## DeepinViewX Network Camera Firmware Version: V5.9.20 Release Note

<b>Firmware Basic Information</b>	Firmware Version:	V5.9.20 build 251217 V5.9.20 build 260204
-----------------------------------	-------------------	--

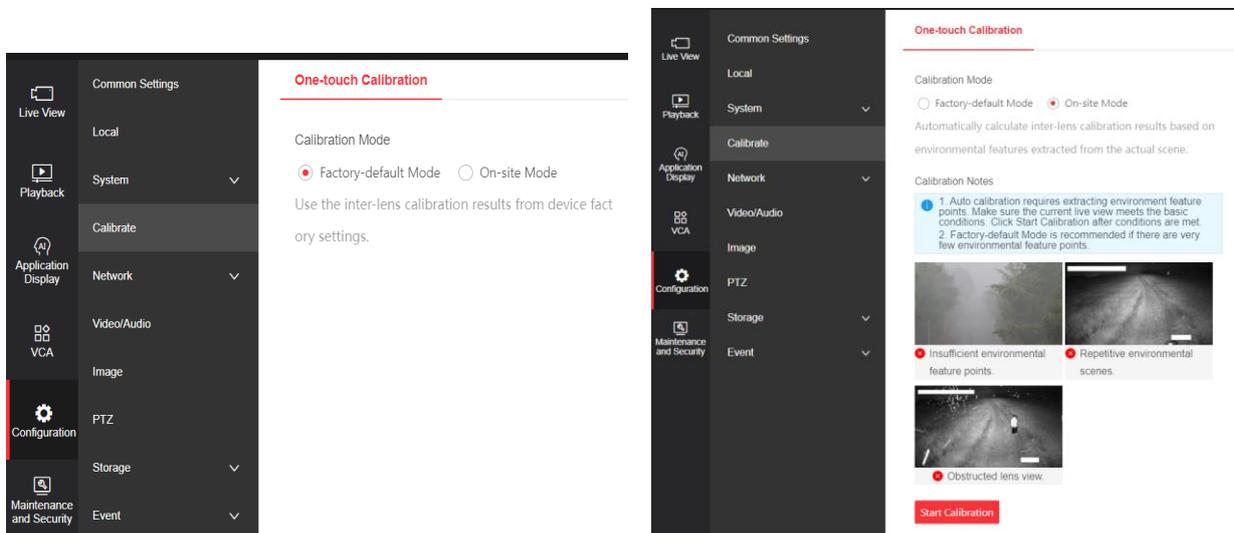
5. The 7 series triple lens perimeter large model camera supports on-site automatic calibration function.

**Factory-default Mode:** Use the inter-lens calibration results from device factory settings.

**On-site Mode:** Automatically calculate inter-lens calibration results based on environmental features extracted from the actual scene.
